Proposed Waikato District Plan - Stage 2
Chapter 15.11 Mine Subsidence Risk Area
Specialist Input Review

1 Introduction and Purpose of Report

Figure 2.5: Huntly East Mine Subsidence Area Overlays compared with the different risk zones for surface subsidence identified by RDCL (Zones A to C and Roadways).

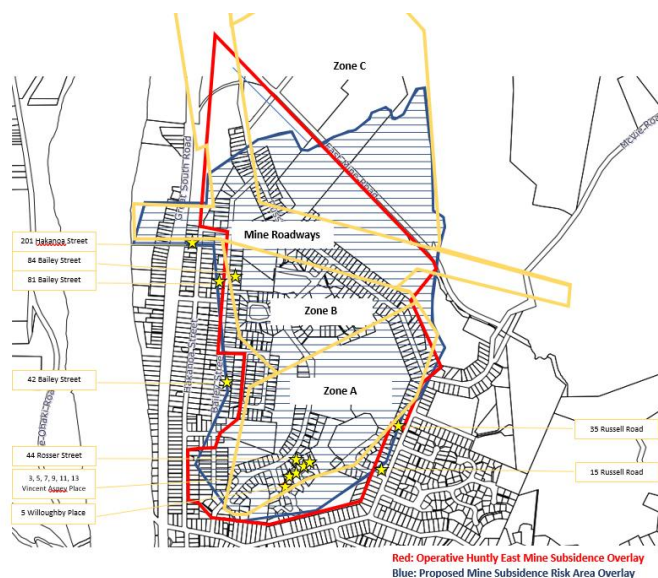
Both overlays include areas of measured settlement and extend out over most of the areas of mine ground related to the East Mine workings (East of the river). Neither plan includes the Historic workings to the West (beyond the scope of these studies).

There are however differences between the existing and proposed overlays as follows:

- The northern boundaries are quite different. Both extend across undeveloped land to the north above areas of long wall mining (areas in Zone C), but neither include all of Zone C. The overlays have very different interpretations at the northern end of East Mine Road. If all of Zone C is not to be included, then I see more justification for using the East Mine Road boundary (as the existing overlay allows for) as a delineator of the northern limit.

- The proposed Mine Subsidence Risk Area overlay extends to the west of the current Huntly East Mine Subsidence Area overlay where the roadways head west and go under the river. This is an area of very low subsidence risk as noted above and by RDCL. But it is an area where gas accumulation may occur as noted by IRBA. It is true that underground roadways and drives underlie this area, however, the subsidence risk in this area is significantly lower (by an order to magnitude) than for Zones A and B. Noting the risk of gas, in my opinion, does not increase the risk of subsidence and the gas accumulation potential (if it does in fact occur) is not sufficient in my understanding to result in these properties being subject to the same subsidence rules as those in Zones A and B.

- To the south, about Zones A and B the overlays are similar (but not the same). The main difference in my interpretation is that the operative overlay has been matched to property boundaries and road networks so that properties fall either completely within or outside of the subsidence area. The proposed change is largely based on a projection up from the old workings and in many places, this results in the boundary crossing through properties (such that different rules will apply to different parts of the property). Within the accuracy of defining the extent of subsidence effects and without redoing this work (beyond the scope of the review) I consider these to be broadly similar, given the differences are at the margins where any effects are likely to be small (e.g. <10mm). However, the current operative overlay is likely to be much easier to administer and clearer to property owners and developers.

I consider for ease of boundary management and to better reflect the different risk profiles across the site that there is a case to maintain the operative subsidence overlay as proposed by the Huntly Community Board.

- If the proposed Mine Subsidence Risk Area overlay is adopted, it will require modification as it currently crosses through properties and will be difficult to interpret and administer.
